**SECTION 00 91 05  
ADDENDUM NUMBER 5**

**DATE:               SEPTEMBER 7, 2017**

**PROJECT:           ORCHARD VALLEY CLUBHOUSE HVAC RENOVATIONS  
2411 W ILLINOIS AVENUE  
AURORA, ILLINOIS 60506**

**PROJECT NO:       17-253-1110**

#### **4.03 DRAWING M410 - TEMPERATURE CONTROLS AND DETAILS**

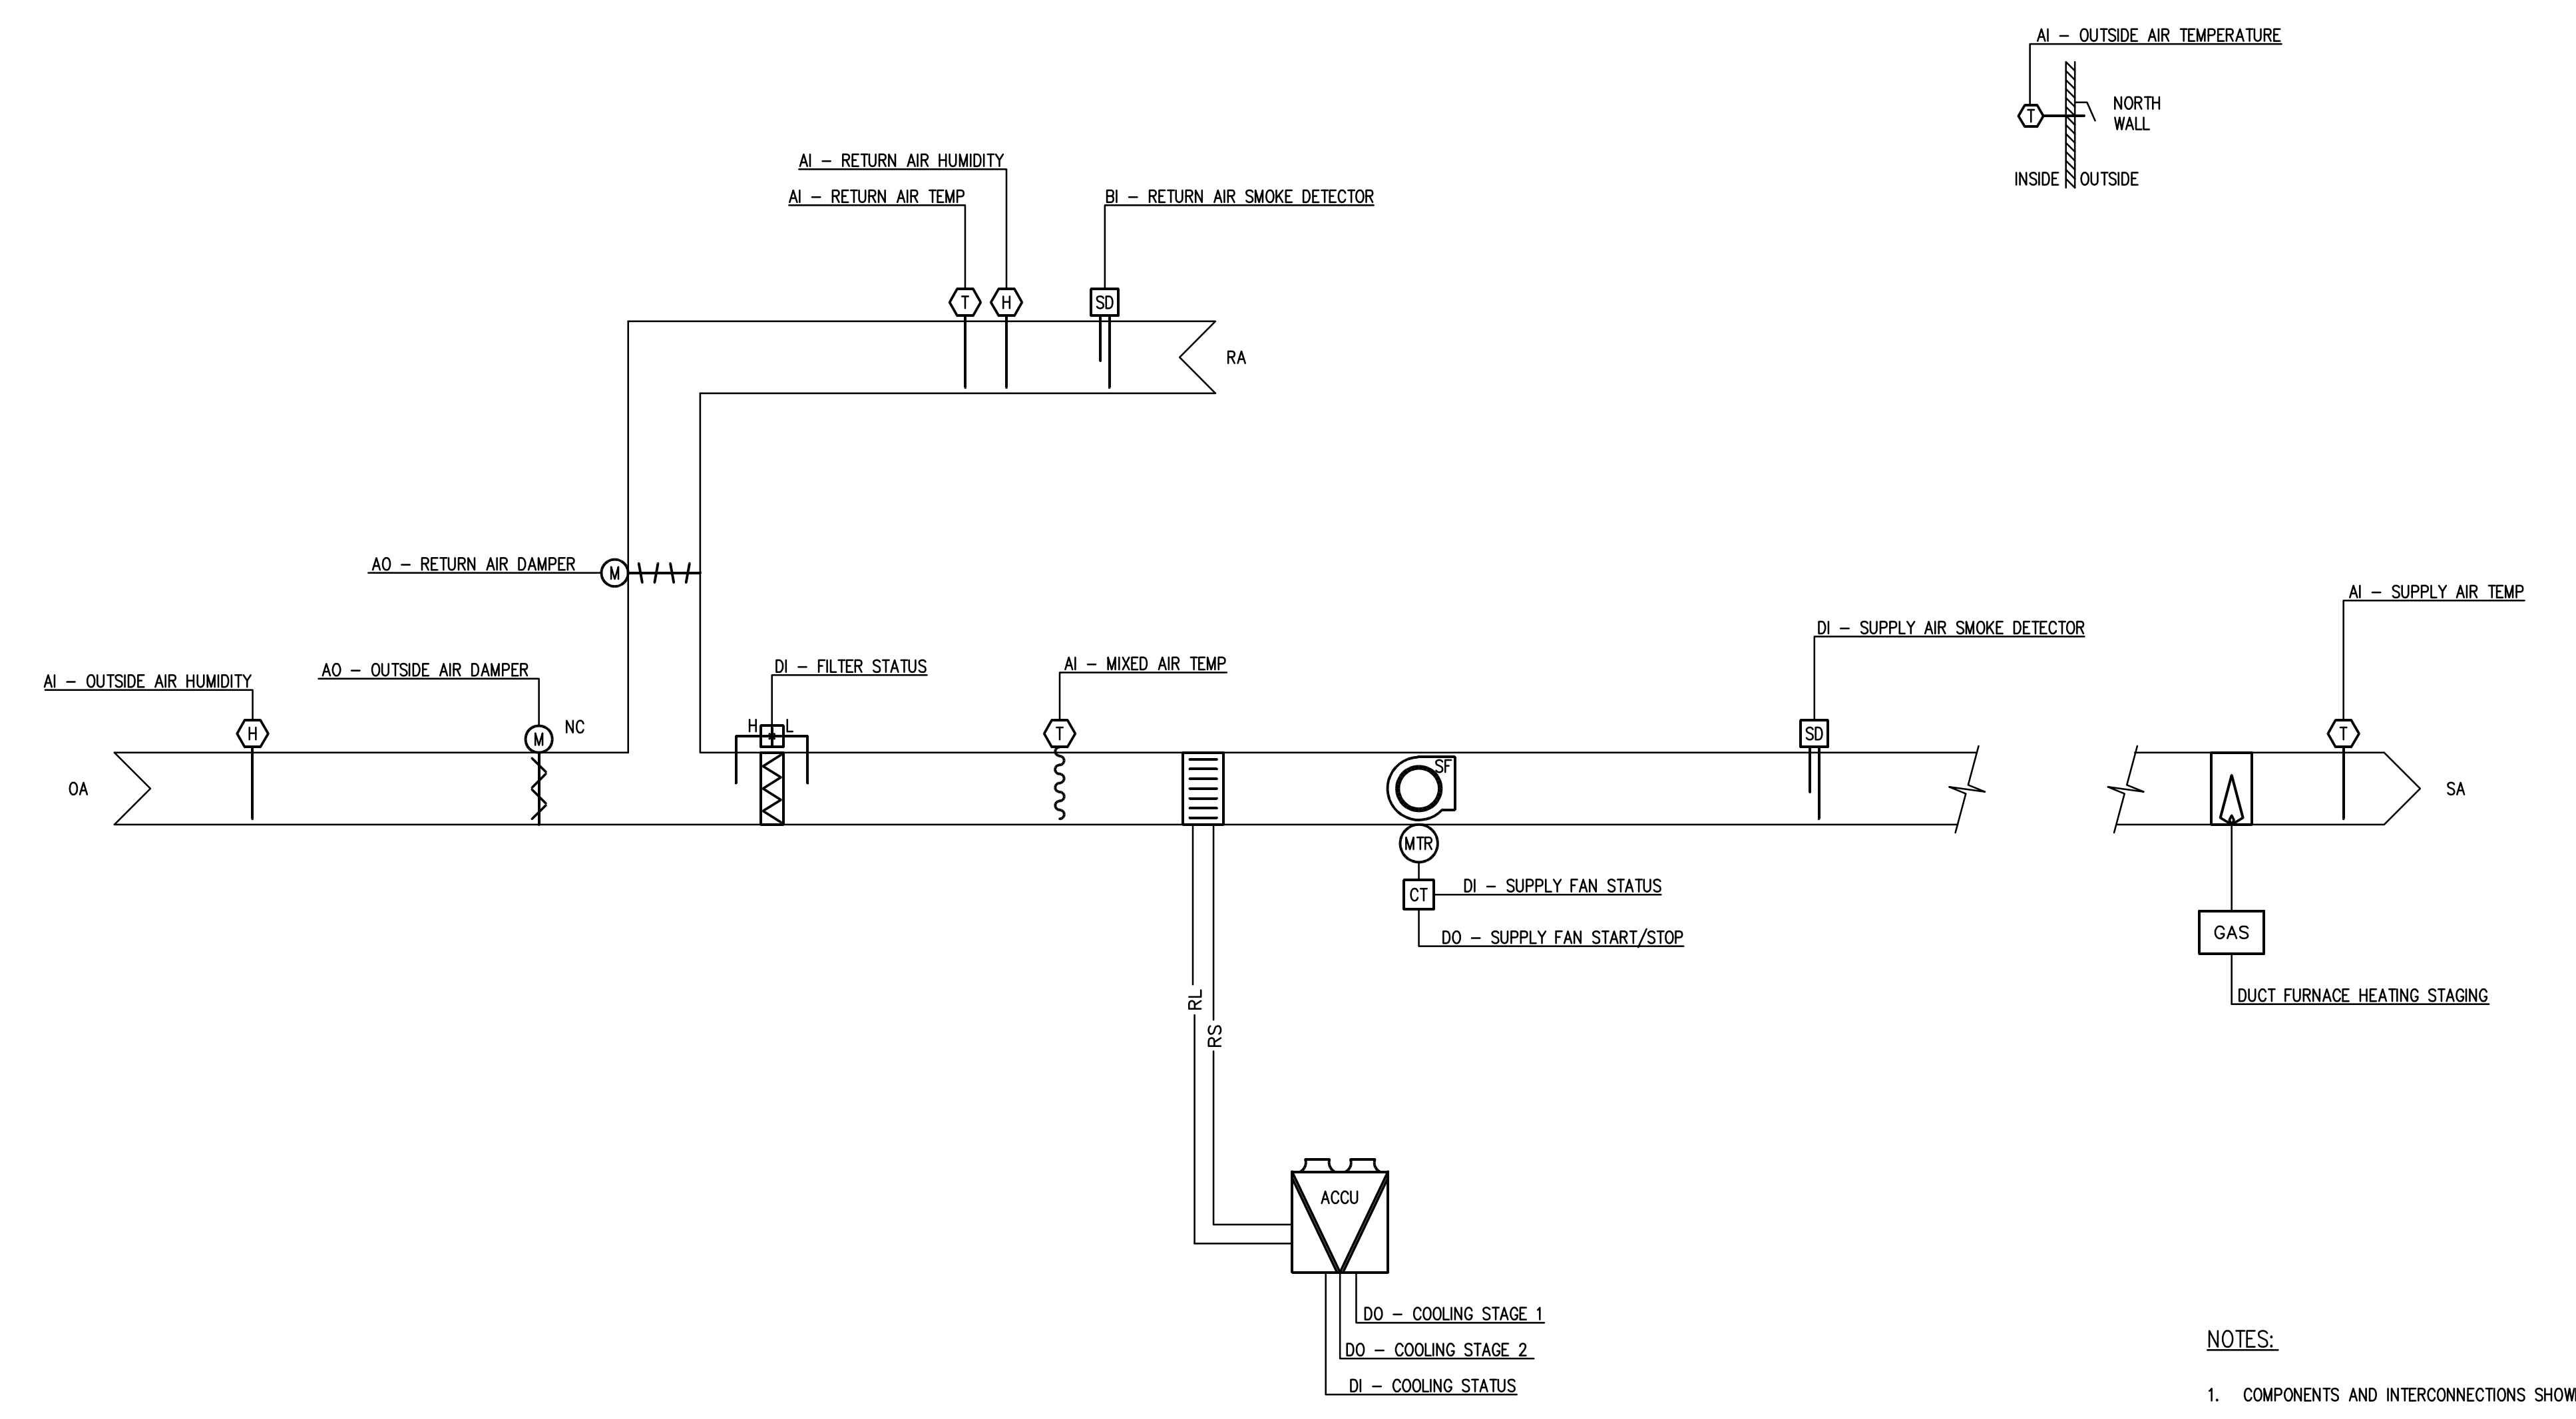
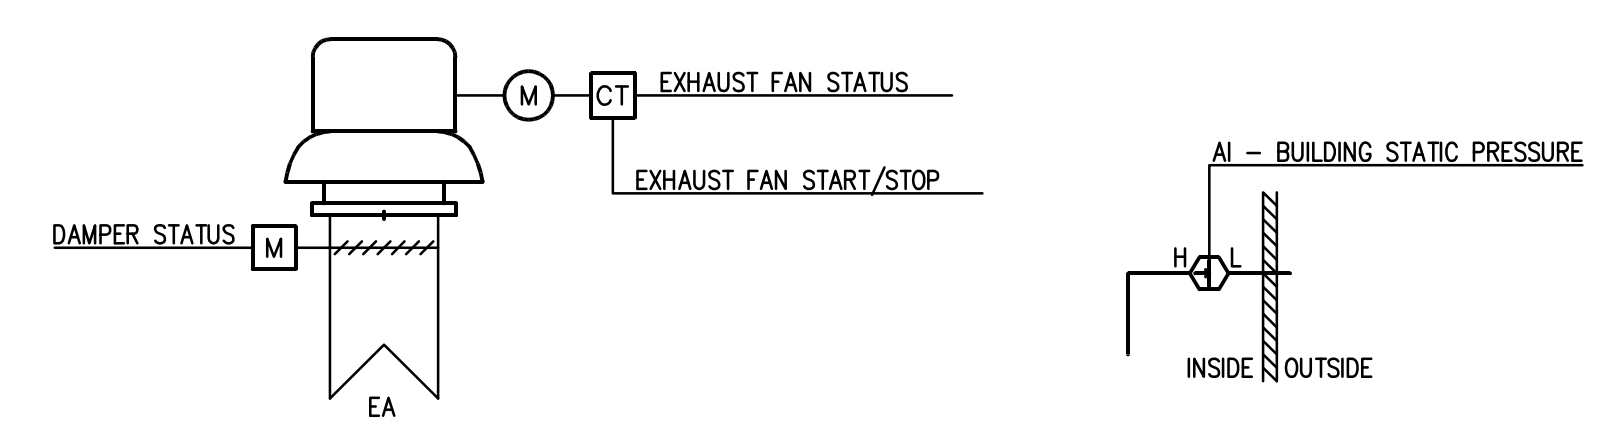
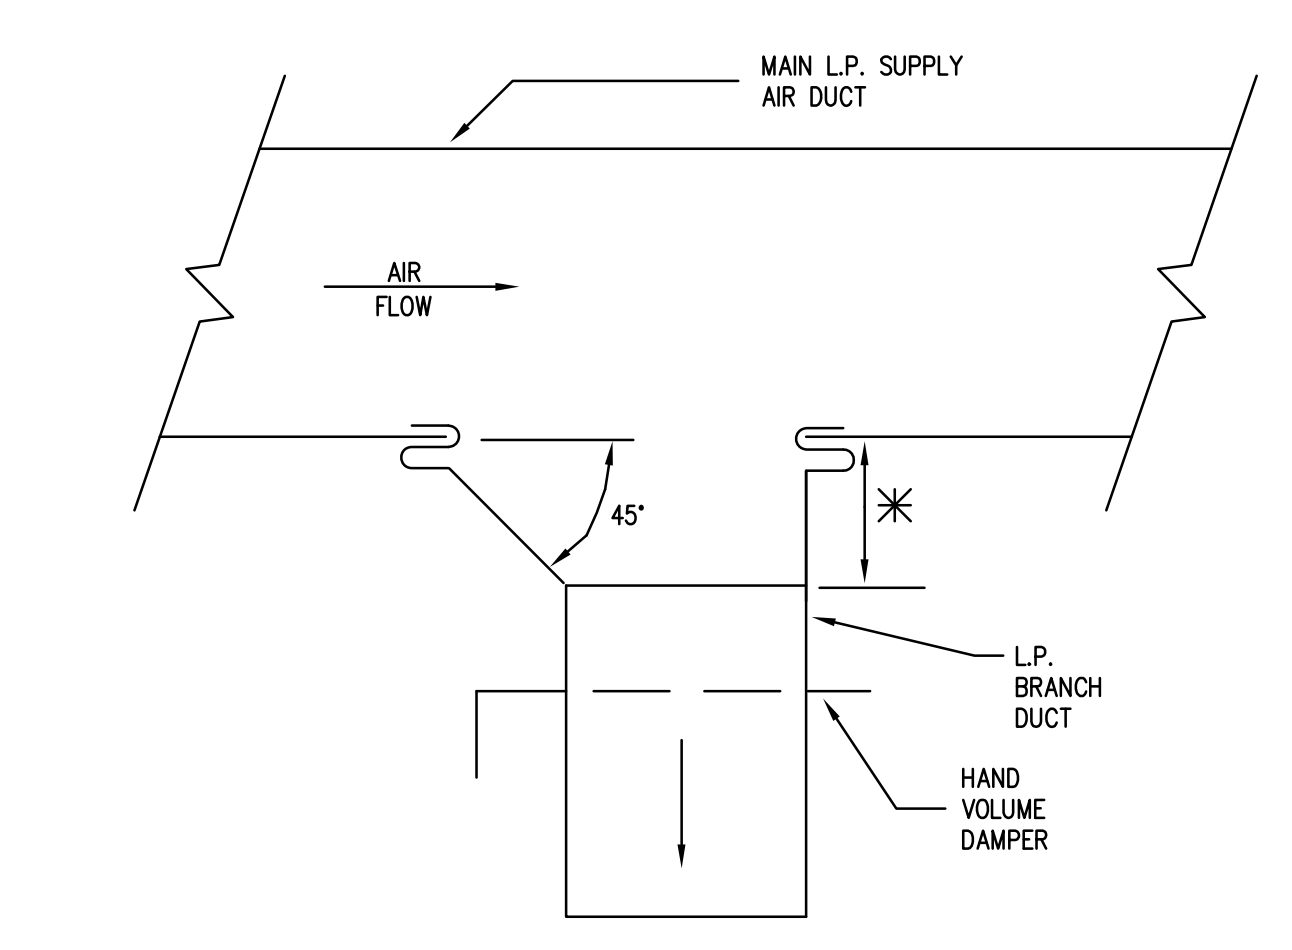
A. Delete this Drawing in its entirety and replace with revised Drawing M410 - TEMPERATURE CONTROLS AND DETAILS (attached).

### ALTERNATE NO. 2 - EXISTING DINING ROOM AHU AND LOWER LEVEL AHU

ALTERNATE NO. 2 - PROVIDE GRAPHICS OF ALL VRV EQUIPMENT AND AVAILABLE POINTS SHALL BE CREATED/INTERFACED INTO THE BUILDING AUTOMATION SYSTEM.
